PG&E Letter DCL-20-092

Diablo Canyon Units 1 and 2
Docket No. 50-275, OL-DPR-80
Docket No. 50-323, OL-DPR-82
License Amendment Request 20-03
Proposed Technical Specifications and Revised License Conditions for the
Permanently Defueled Condition

Subject: Proposed Changes to Licenses and Technical Specifications to Reflect a Permanently Defueled Condition

Figure 2.1.1-4
REACTOR CORE SAFETY LIMIT

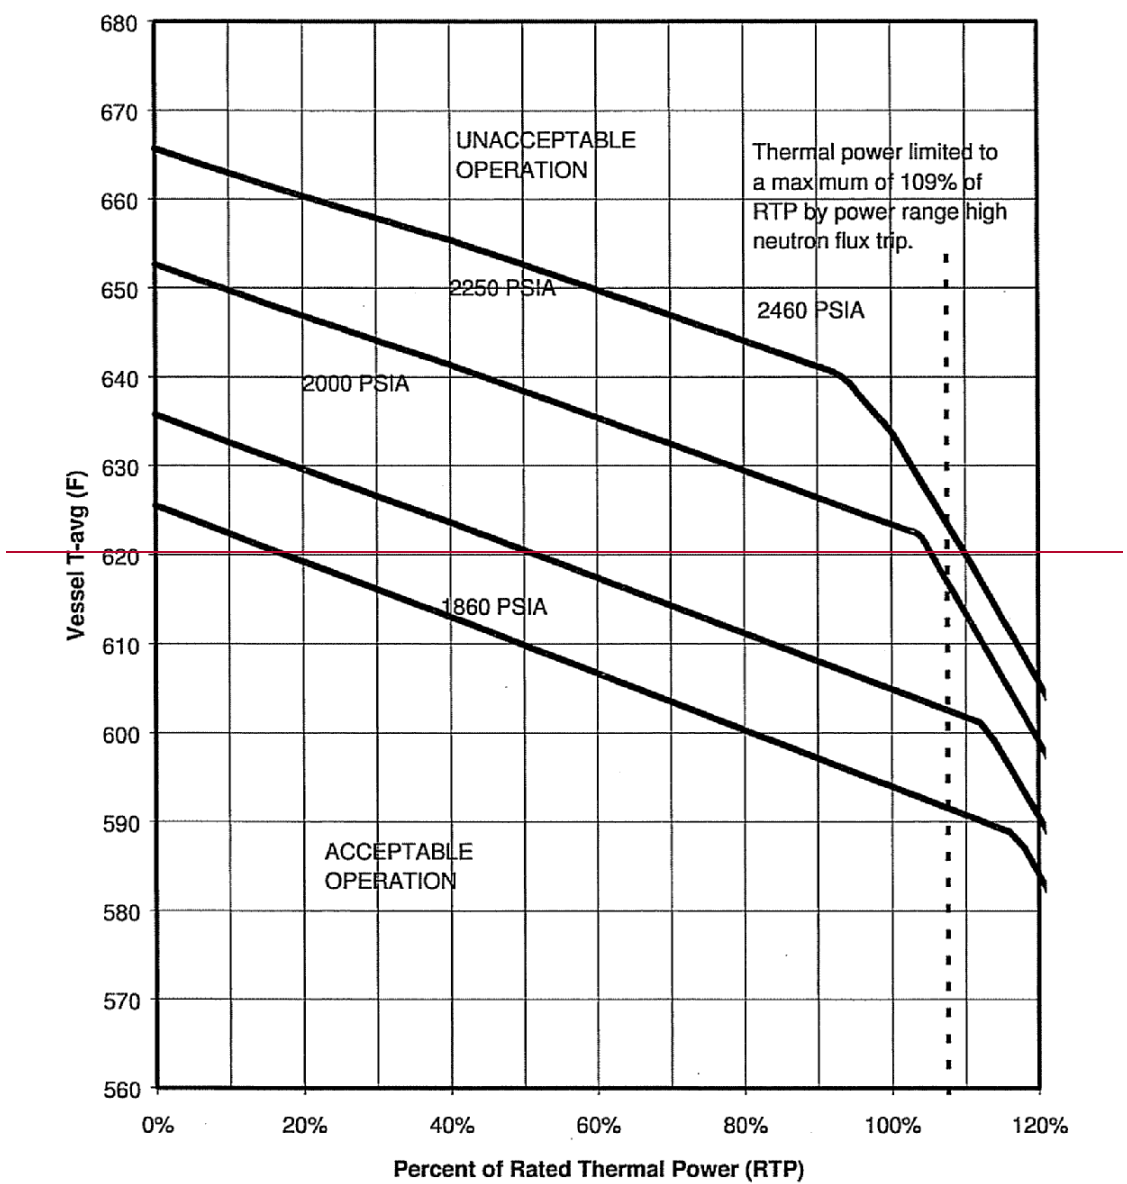
TS 2.2, SL Violations	TS 2.2.1 and 2.2.2 describe actions to take if TS 2.1.1 or 2.1.2 is violated. Because TS 2.1.1 and 2.1.2 are being proposed for deletion, TS 2.2.1 and 2.2.2 are no longer required and are proposed for deletion.
Figure 2.1.1-1, Reactor Core Safety Limit	<p>Figure 2.1.1-1 provides the acceptable values for thermal power, RCS highest loop average temperature, and pressurizer pressure to meet the requirements of TS 2.1.1.</p> <p>The limits provided in Figure 2.1.1-1 prevent overheating of the fuel and cladding, as well as possible cladding perforation that would result in the release of fission products to the reactor coolant. These limits are applicable is MODES 1 and 2.</p> <p>Pursuant to 10 CFR 50.82(a)(2), once PG&E docket the certifications required by 10 CFR 50.82(a)(1), the licenses for DCPD Units 1 and 2 will no longer authorize operation of the reactors or placement or retention of fuel in the reactor vessels. Since the SLs apply to an operating reactor, they have no function in the permanently defueled condition. Therefore, this figure is proposed for deletion.</p>

~~In MODES 1 and 2, the combination of THERMAL POWER, Reactor Coolant System (RCS) highest loop average temperature, and pressurizer pressure shall not exceed the SLs specified in Figure 2.1.1-1.~~

FIGURE 3.7.17-4

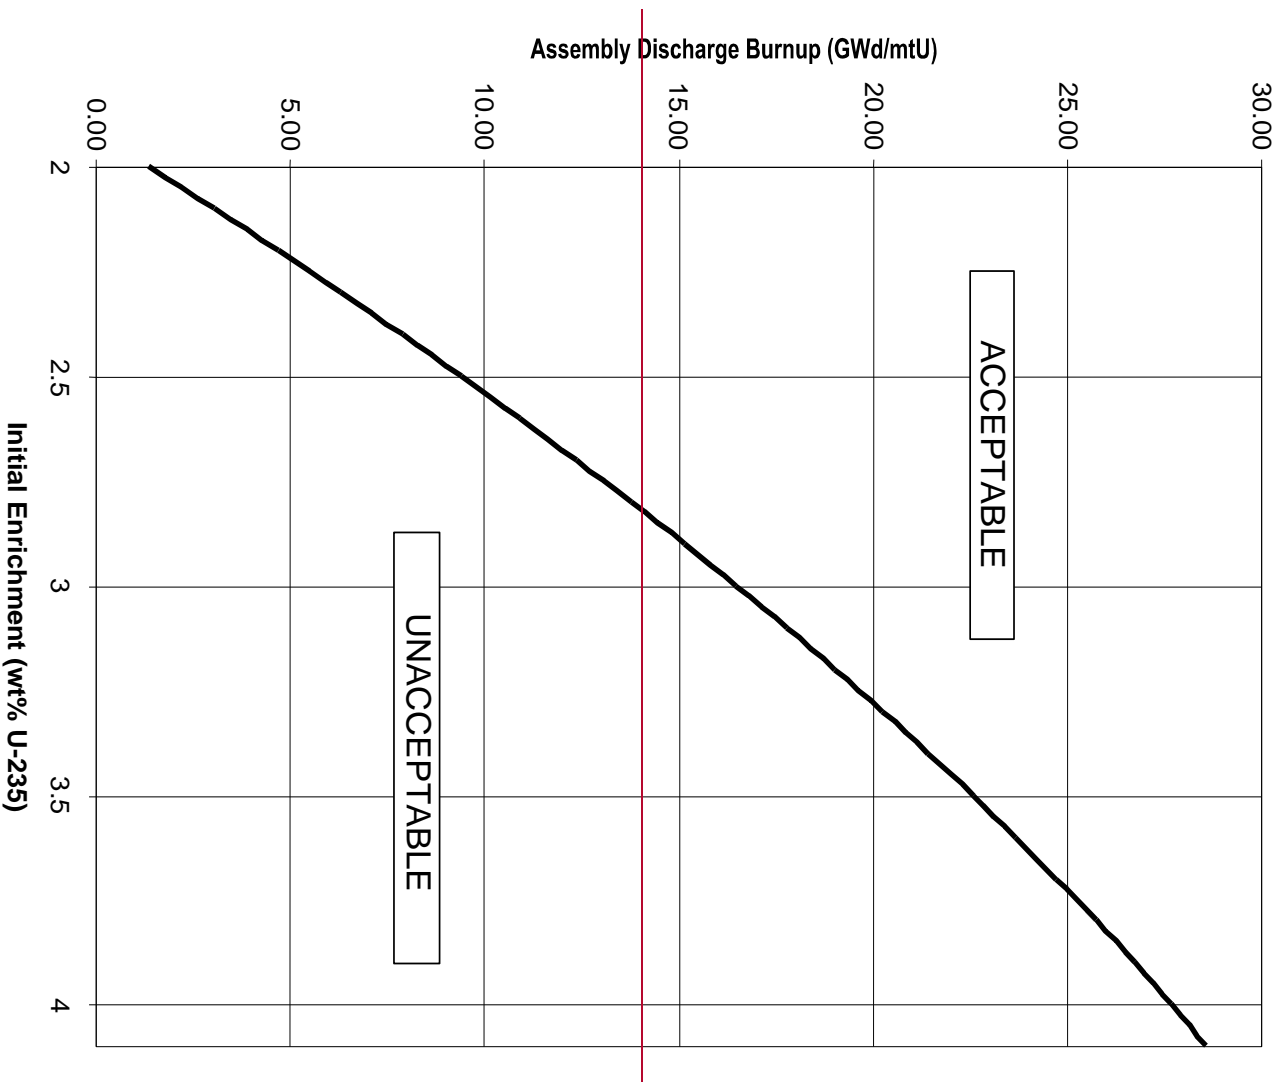
TS 3.7.17 – This TS places restrictions on the placement of fuel assemblies within the SFP, to ensure the k_{eff} of the spent fuel storage pool will always remain less than or equal to 0.95 at a 95 percent probability, 95 percent confidence level, for a postulated reactivity insertion accident or a boron dilution event. This TS is applicable when any fuel assembly is stored in the SFP and will be retained in the PDTs (including Figures 3.7.17-1, 3.7.17-2, and 3.7.17-3) with the following changes. TS 3.7.17.b, 3.7.17.c, and the associated Figure 3.7.17-4 are being proposed for deletion. TS 3.7.17.b, 3.7.17.c, and the associated Figure 3.7.17-4 were added to the DCCP TS via License Amendments 183 and 185 approved by the NRC on November 21, 2005 (Reference 23). These amendments allowed the installation and use of a temporary cask pit spent fuel storage rack for Units 1 and 2 during Cycles 14-16. This TS LCO is historical in nature and will not be applicable during decommissioning. Therefore, TS 3.7.17.b, 3.7.17.c, and the associated Figure 3.7.17-4 are proposed for deletion.

- ~~1. An initial enrichment \leq 4.1 wt% U-235;~~
 - ~~2. A discharge burnup in the “acceptable” region of Figure 3.7.17-4; and~~
 - ~~3. A minimum decay time of 10 years since being discharged from the reactor.~~~~
 - ~~c. The total combined spent fuel pool capacity in the permanent and cask pit storage racks, for Cycles 14 – 16, is limited to no more than 1433 irradiated fuel assemblies. This limit does not apply for an emergency core offload.~~

- e. ~~Fuel assemblies with discharge burnup in the "acceptable" region of Figure 3.7.17-4;~~
 - f. ~~Fuel assemblies having a 10 year minimum decay time since being discharged from the reactor; and~~
